REFUSAL
 REFERRAL

APPLICATION #
497525

2012-20 WHARTON STREET (SEC OF S CAPITAL, SWC OF S WOODSTOCK, THRU TO REED)

CDR PROJECT APPLICATION FORM

proposed site plan

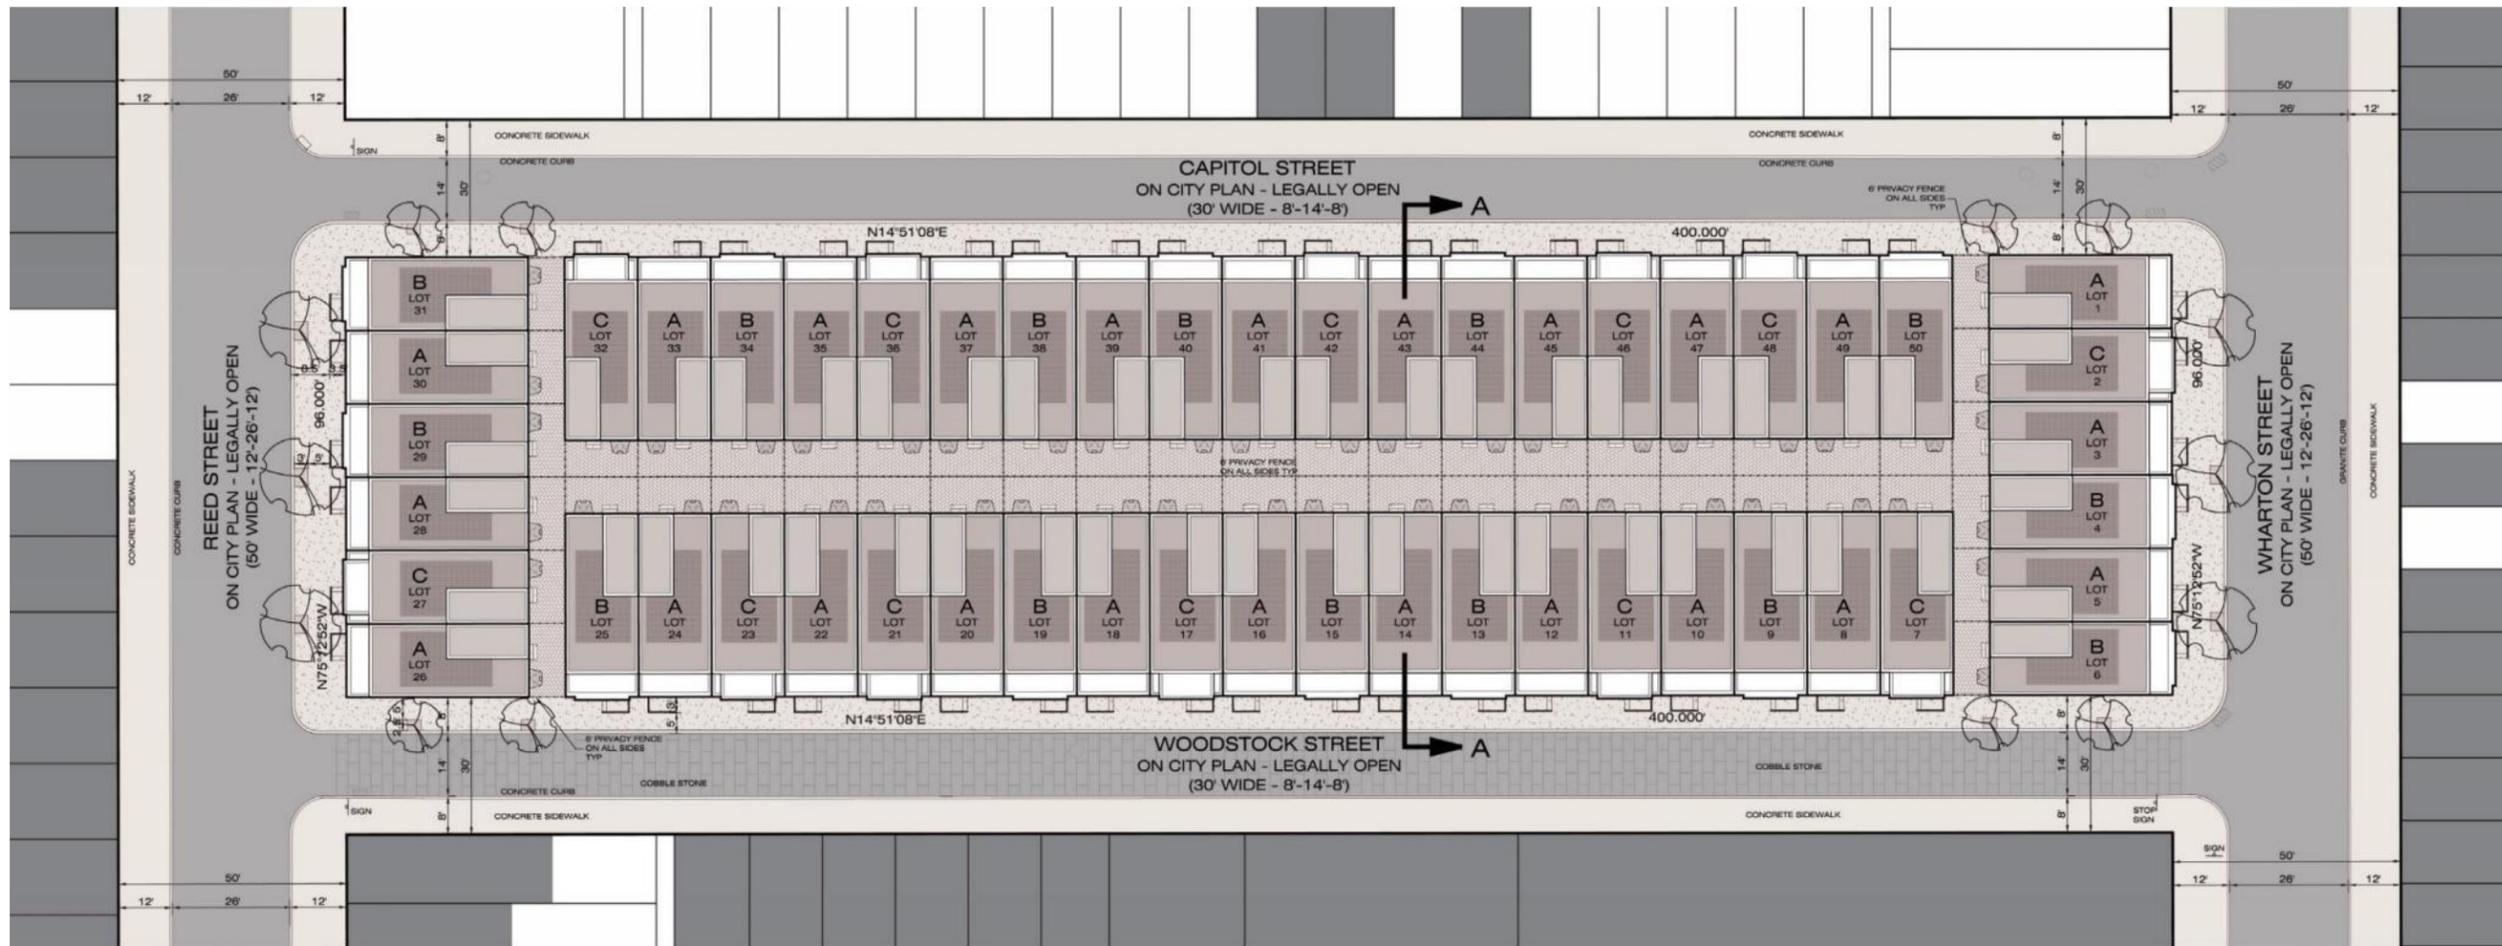
- The proposed projecting bays on the Type B and C units must be approved by Streets Department (MSB, Room 940, Phone: 215-686-5500).
- Unit Type A and B both identify “balconies” above the 2nd floor front. These meet the definition of roof decks and must comply with the provisions of §14-604(5). See refusal.
- The guard rails on the roof decks located above the 2nd and 3rd floors are not shown on the plans. Roof deck guard rails may not exceed 48 inches in height. (§14-604(5)(b)).
- The units are Lots 36, 44 and 46 were not labeled with a type of unit. I believe they are Type C, Type B and Type C, respectfully.
- Confirm the total Gross Floor Area (GFA) measurement according to §14-202(4). Please note the cellar is not to be included in this measurement (§14-202(4)(b)(.2))
 - Based on the lot area and FAR noted on the plans, the total GFA calculated is 93,296.64 ft²

CODE REFERENCE	PROPOSED USE IS REFUSED FOR THE FOLLOWING:		
<i>Table 14-602-3</i>	THE PROPOSED USE, SINGLE FAMILY HOUSEHOLD LIVING, IS PROHIBITED IN THIS ZONING DISTRICT.		
<i>§14-604(5)(a)</i>		REQUIRED	PROPOSED (TYPE A & B UNITS)
	ROOF DECK SETBACK	5 FT	0 FT
